RE: SEQRA

Review of Visual Character & Visual
Analysis, Sailor's Cove on the Hudson
City of Kingston
Ulster County, New York

The Environmental Simulation Center, Ltd. (ESC) was retained by the City of Kingston to review the Visual Character (Section 3.9) and the Visual Analysis (Appendix L) of the Draft Environmental Impact Statement (DEIS) produced for Sailor's Cove on the Hudson, dated December 23, 2005.

The above image replicates a portion of the simulation for viewpoint 70. The annotation has been added to call out elements of the simulations that are discussed below:

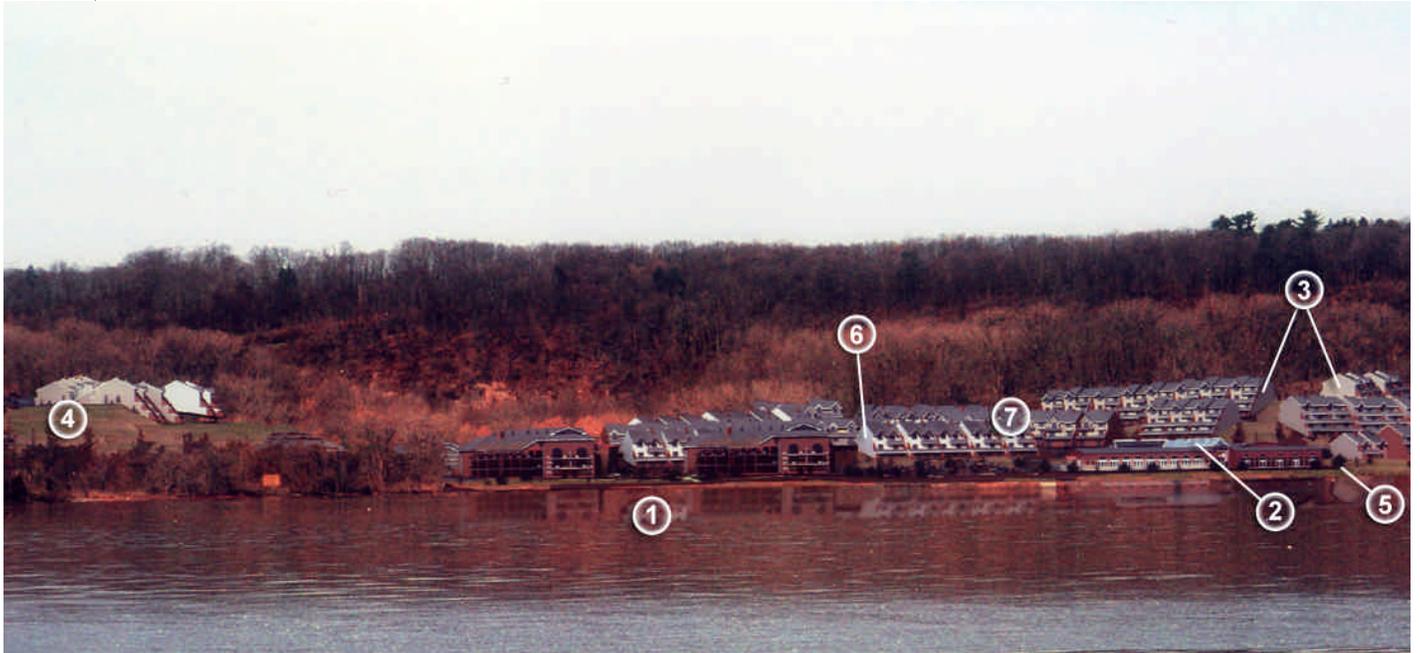
1. The simulation shows the action's reflection off the water.
2. The skylight of the large center building was simulated to show glare / reflected light from certain angles.
3. The photo simulations have a light source correctly depicting the time of day that the photographs were taken. This results in shading that is appropriate to time of day, color of the building and the angle of the action vis-à-vis the viewpoint location.
4. The applicant has placed the buildings of the action on green lawns where appropriate.

5. The trees of the landscape plan are simulated in leaf-off condition at their size at planting, which means they provide very little screening, certainly a worse case condition.
6. The buildings liberally use visible shades (white and light gray) along with brick and tan colors that tend to blend, again ensuring a reasonable worse case simulation.
7. The buildings of the action are simulated with a good deal of architectural articulation, which 1) make the buildings of the action look more realistic, and 2) help the viewer better understand the relationship of the buildings to the surrounding context.

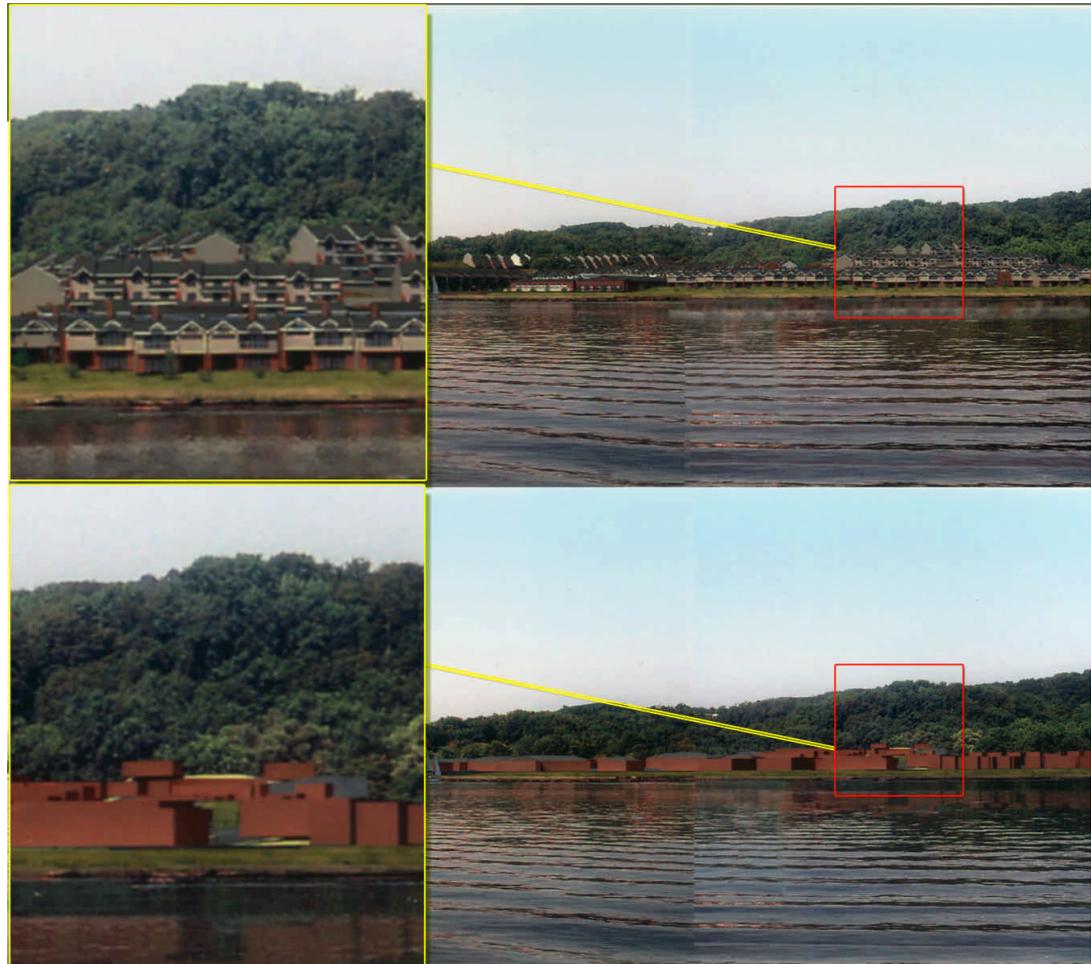
Part of the text describing this viewpoint states:

“The earth tone and natural colors of the buildings and roof significantly contribute to reducing the impacts associated with this view. In particular, the colors of the townhouse and condominium units blend the structures into the existing mined landscape.” (pg. 168)

This simulation does not show an action that blends “into the existing mined landscape.” The simulation shows that the action is visually prominent from this viewpoint and the text describing the potential visual impacts from these viewpoints needs to accurately interpret the evidence provided by the photo simulations. Most of the other viewpoints seem to contain text in the Potential Impacts section on page 167 that do not accurately describe the potential impacts shown in the photo simulations. The Potential Impacts section needs to be rewritten with the photo simulations guiding the analysis.
